Intel[®] Mobile Pentium[®] II Processor Specification Update

Release Date: November 2000

Order Number: 243887-026

The Mobile Pentium[®] II processor may contain design defects or errors known as errata which may cause the product to deviate from published specifications. Current characterized errata are documented in this Specification Update.

Old Mobile Pentium® II Processor in Mini-Cartridge Package Label with Supplier Matrix Mark

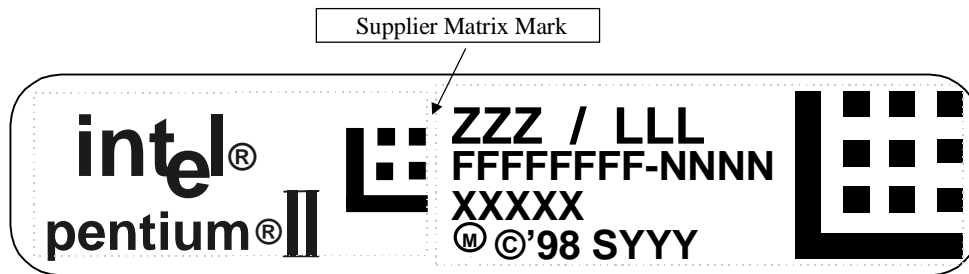
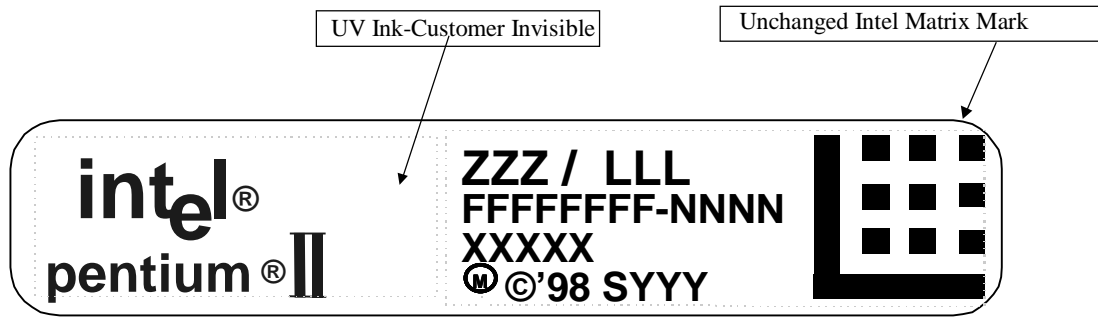
April 2000	-020	Updated the "Pentium II Processor Mobile Module Markings" and "Pentium II Processor Mobile Module With On-die Cache Markings" sections
June 2000	-021	Added Erratum B59.
July 2000	-022	Added Erratum B60, B61
August 2000	-023	Added Erratum B62
September 2000	-024	Added Erratum B63, B64; Revised Erratum B36, B53, B57; Added Documentation Changes B20, B21
October 2000	-025	Updated the reference to the published documents in the Preface; Added Erratum B65; Added Documentation Changes B22, B23
November 2000	-026	Added Erratum B66

New Mobile Pentium® II Processor in Mini-Cartridge Package Label with Supplier Matrix Mark Removed

Figure 2. Workaround Flowchart: SMBALERT#-Driven System

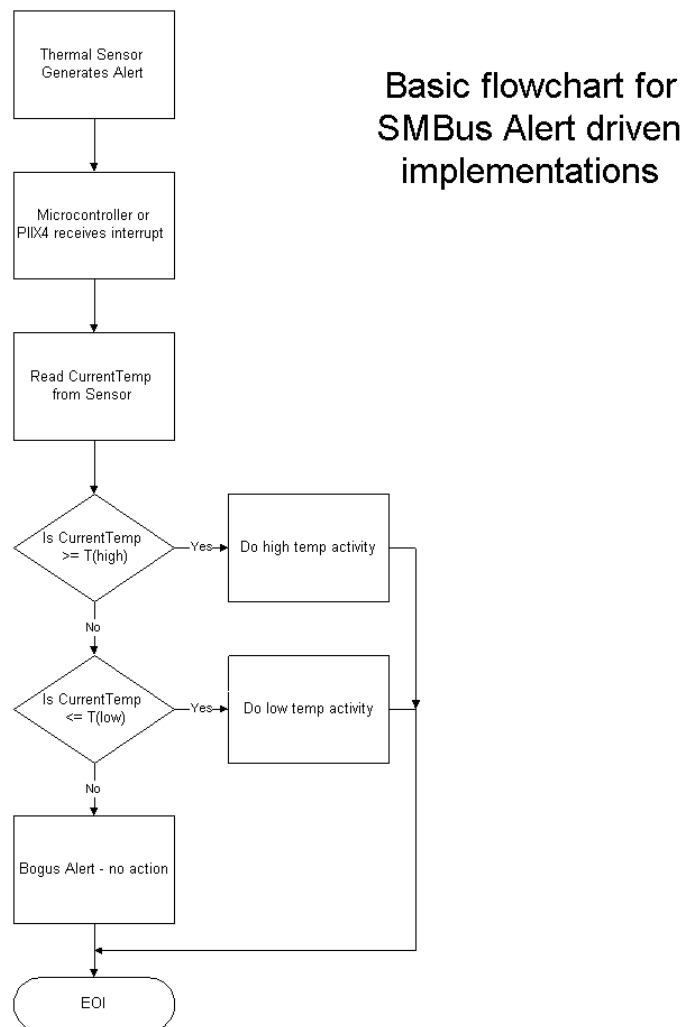
B30. Thermal Sensor May Assert SMBALERT# Incorrectly

Under the conditions described below, the thermal sensor incorrectly generates the SMBALERT# interrupt. All of the following conditions must be met to trigger a false interrupt:

1. Before servicing an interrupt from the thermal sensor, read and compare the processor thermal reading with the threshold limits (T_{HIGH} or T_{LOW}). Figures 2 and 3 provide basic flowcharts for the implementation of this workaround in an interrupt driven system.
2. If the firmware implemented polls the Status Register only, then before taking any action, re-read the temperature register and do a comparison with the alarm threshold limits (T_{HIGH} or T_{LOW}) to determine if the value is actually still within the temperature window.

3. Use a temperature polling scheme to monitor the processor temperature.

Figure 5.6. Cross Sectional View with Vertical Dimensions

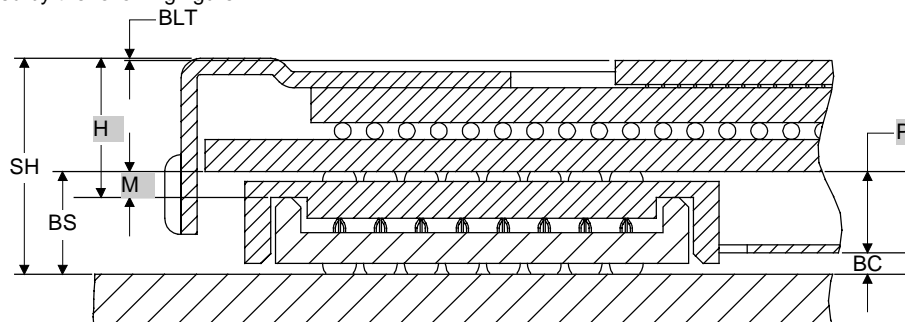
B1. Mislabeled Vertical Dimension Parameters

Figure 5.6 in the *Mobile Pentium® II Processor at 233 MHz, 266 MHz, and 300 MHz* datasheet should be replaced by the following figure:

Figure 5.3. Surface-Mount BGA1 Package—Top and Side View

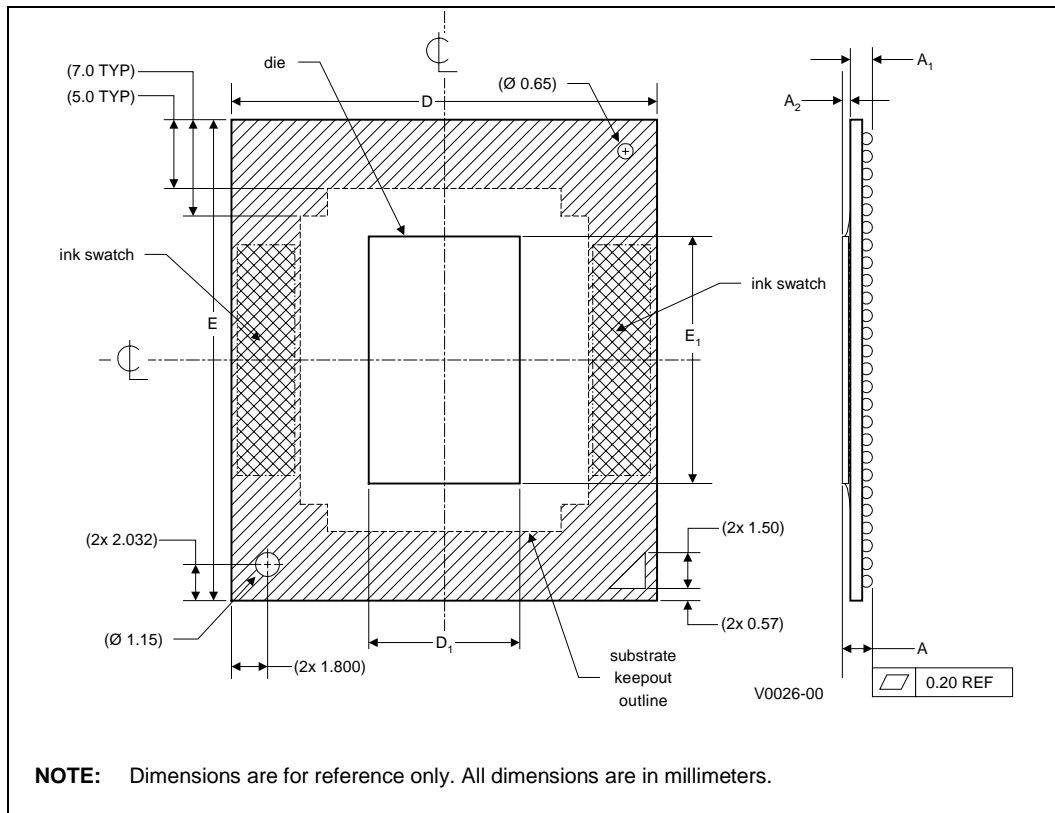
The following table and figures show the updated mechanical specifications for the BGA1 package, listed as Table 5.2, Figure 5.3 and Figure 5.4, respectively, in the *Mobile Pentium® II Processor in BGA Package at 366 MHz, 333 MHz, 300PE MHz, and 266PE MHz* datasheet.

1. The number shown here is different from that in the 243887-010 revision of this specification update. The maximum reference number is used.

Figure 3.3 Generic Clock Waveform

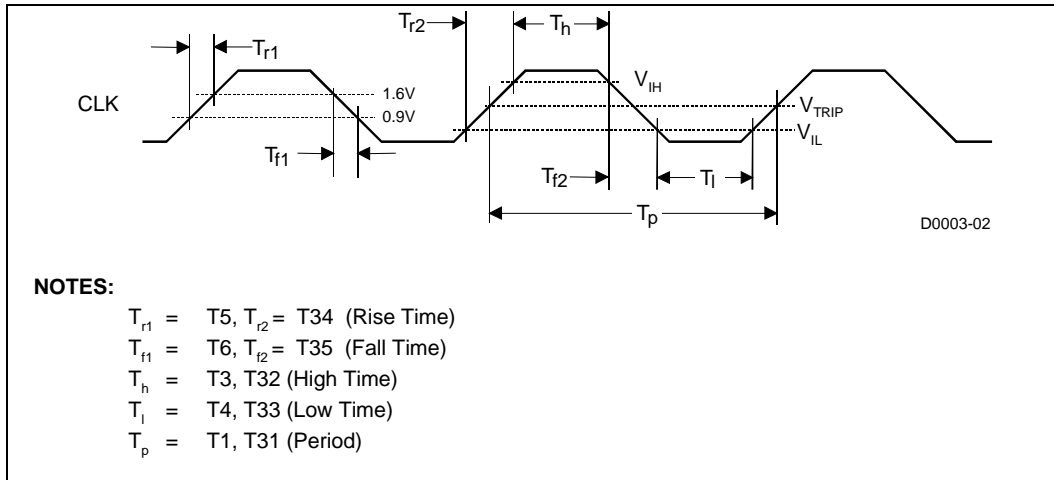
B14. Generic Clock Waveform Figure

Figure 3.3 in *Mobile Pentium® II Processor in Mini-Cartridge Package at 366 MHz, 333 MHz, 300PE MHz, and 266PE MHz* datasheet (Order Number 245108), and the *Mobile Pentium® II Processor in BGA Package at 366 MHz, 333 MHz, 300PE MHz, and 266PE MHz* datasheet (Order Number 245106) has been updated. The following figure is to replace the ones in the above documents.

Figure 1. TAP Gageable Thread Clarification

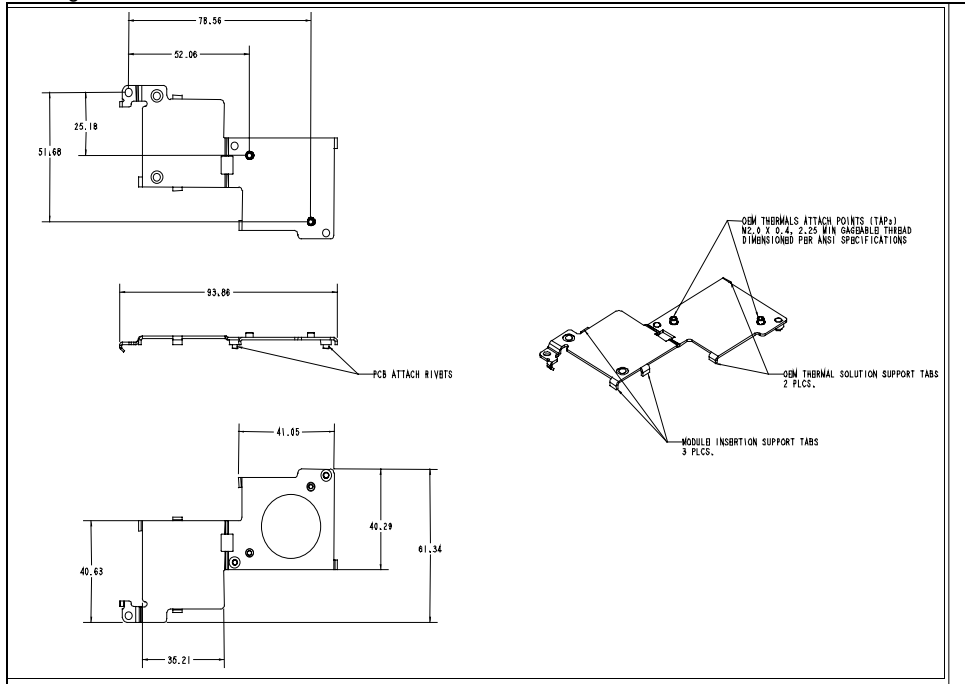
In the *Intel® Pentium® II Processor Mobile Module : Mobile Module Connector 1 (MMC-1)* and the *Intel® Pentium® II Processor Mobile Module : Mobile Module Connector 2 (MMC-2)* datasheets (Order Numbers 243667 and 243668, respectively), the thermal attach point (TAP) gageable thread specification was not clearly identified in Figure 14, of Section 5.2. The following is the TAP clarification:

OEM Thermal Attach Points (TAPs) M2.0 x 0.4, 2.25 min gageable thread dimensioned per ANSI specification.

See Figure 1 below for more information.
